Re: Permit Application Modification for the City of Long Beach's Alamitos Bay Marina Rehabilitation Project

Per our recent email discussion, on behalf of the City of Long Beach (City), Anchor QEA, L.P. is requesting to modify our permit applications for the City's Alamitos Bay Marina Rehabilitation project (USACE file No. SPL-2007-00348-KW). Specifically, we are requesting to modify our permit applications to reflect a change in the volume to be dredged in Basin 1.

Figure 1
Basin1 Contaminated Sediment Dredging Plan
Alamitos Bay Marina Rehabilitation

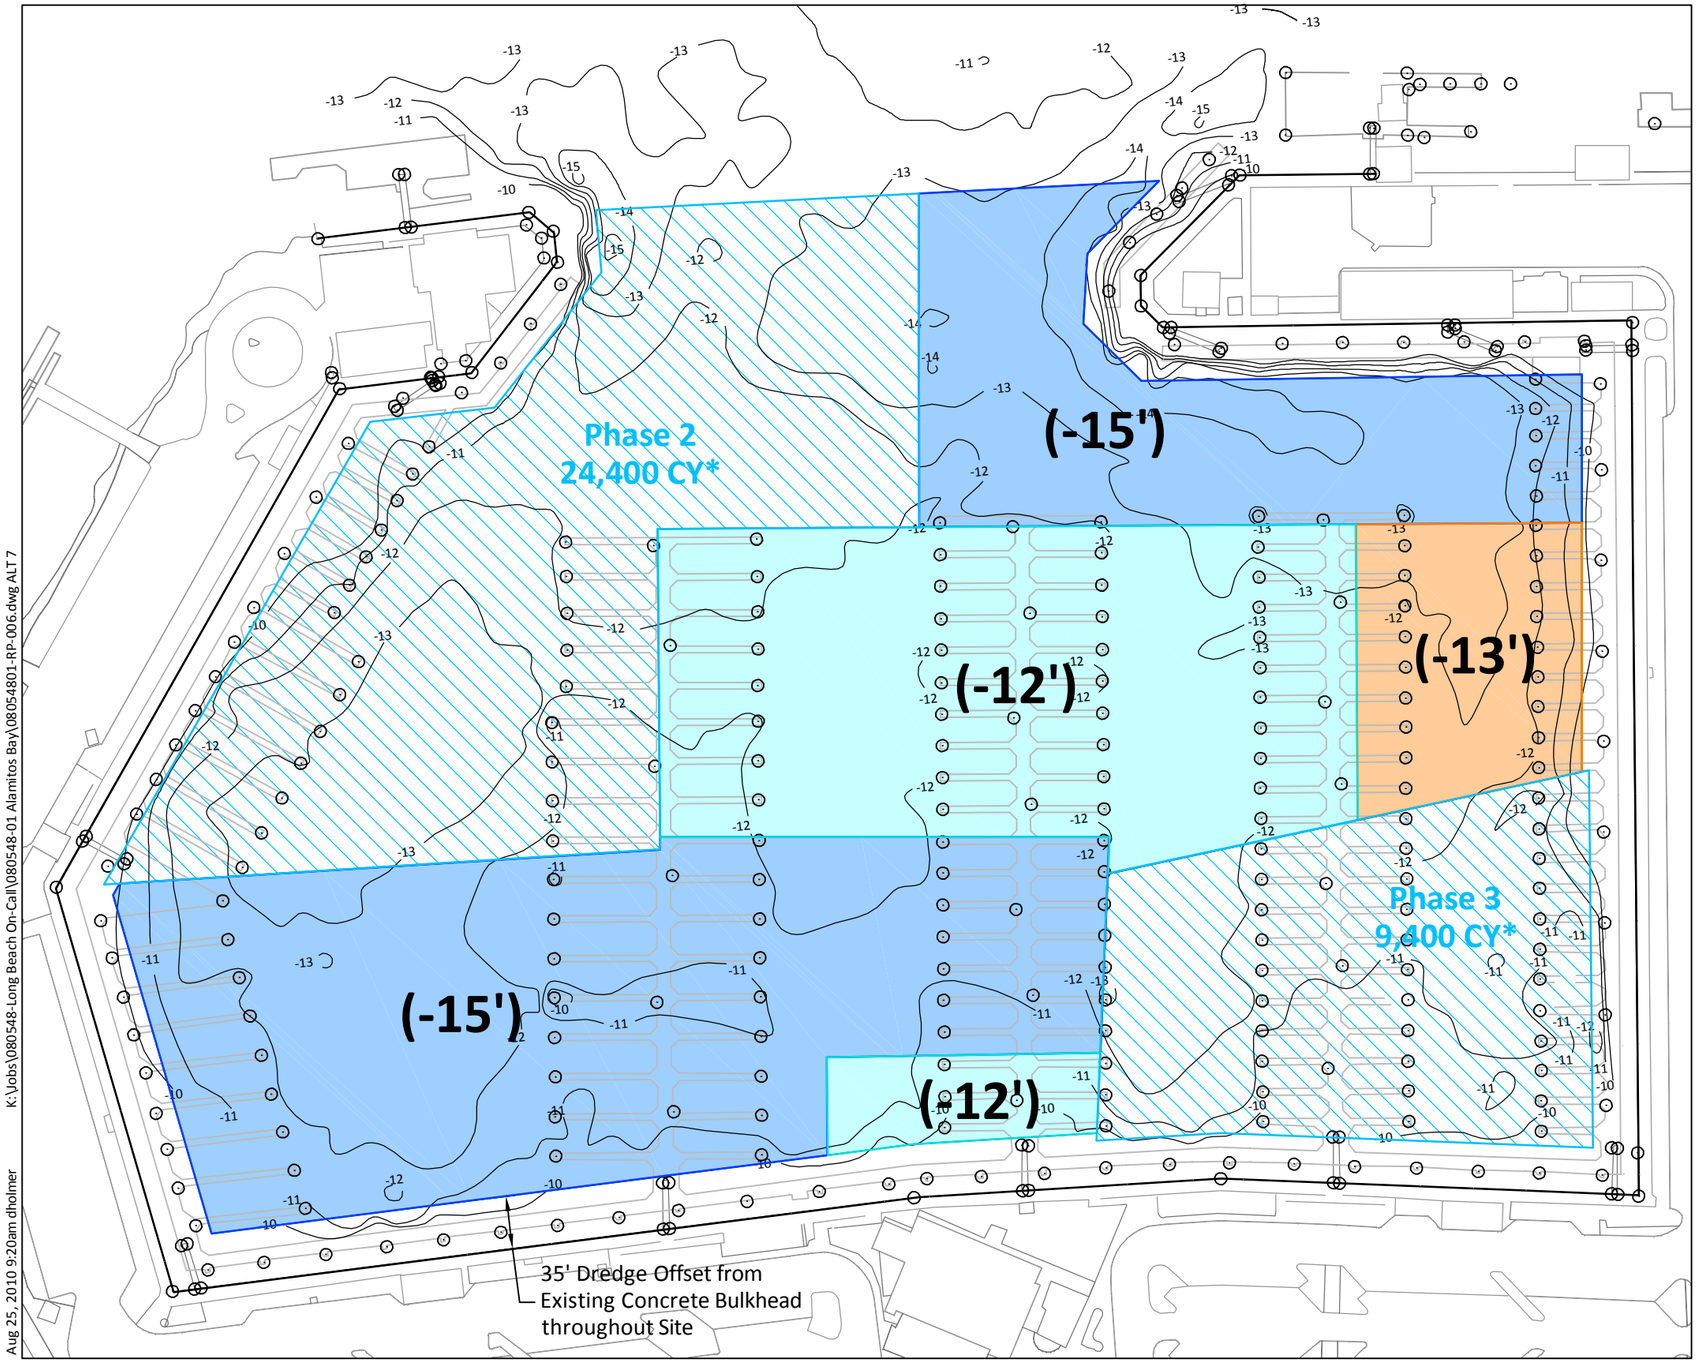
Since submittal of our permit application, the City has progressed in its development of dredging plans in preparation for this specific effort. Based on updated evaluations, the City proposes to increase the volume of dredged material removed from Basin 1 during the initial phase of the project and intended for placement at Middle Harbor, to 41,000 cy (including overdepth). The new proposed plan for Basin 1 is shown as attached Figure 1. The revised dredging volumes are indicated in Table 1 below (note that the Basin 4 volume is also corrected from our prior submittal). The total project volume is now proposed to be 308,158 cy over the span of the project.
